ADDENDUM NO.: 2

DATE OF ADDENDUM: 2/14/13

**Renovations to B-Lot and Additional Parking
Manchester Community College
Manchester, CT
BI – CTC – 440**

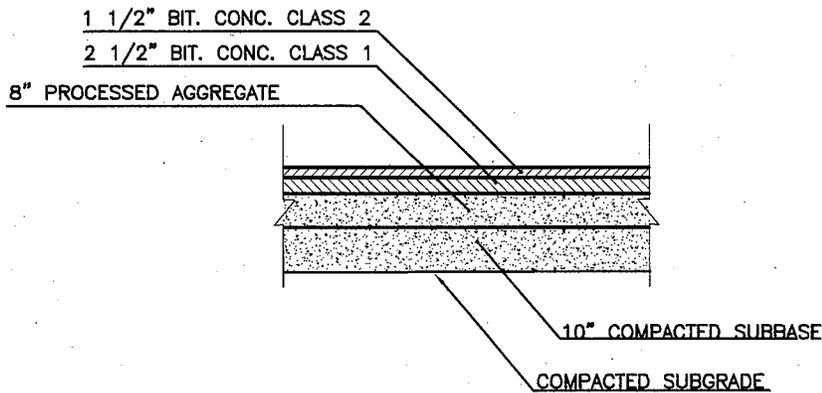
Question 5: There is no curbing shown for three of the areas receiving additional parking on Sheet C2.30 (4 spaces, 4 spaces, 2 spaces). Is Curbing required in these areas?

Response: Yes, curbing is required. Please refer to SKC-2 for line and curb information.

**NEW BITUMINOUS CONCRETE
PAVEMENT SECTION**

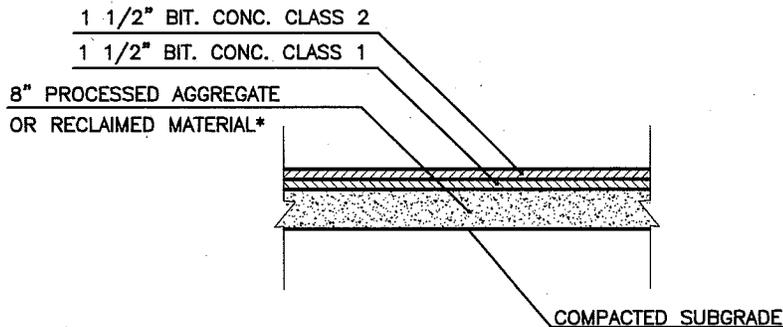
DELETE: NEW BITUMINOUS CONCRETE PAVEMENT SECTION HEAVY-DUTY (ROADWAY) AND NEW BITUMINOUS CONCRETE PAVEMENT SECTION LIGHT-DUTY (PARKING) details from Sheet C6.10.

Question 3: The Heavy Duty Pavement detail on Sheet C6.10 calls out 10" of compacted subgrade. Should this be 10" subbase on compacted subgrade?

REPLACE WITH: SKC-1**Item 2**

Response: Please refer to attached revised details of sketch SKC-1. In the parking areas the Contractor shall reclaim existing bituminous pavement and base to be used as new base per the recommendation in the Geotechnical Report (Section 5). The Contractor shall provide processed aggregate per DOT specifications as needed to obtain a total thickness of 8" throughout the parking area per the revised detail for New Bituminous Concrete Pavement Section Light Duty (Parking).
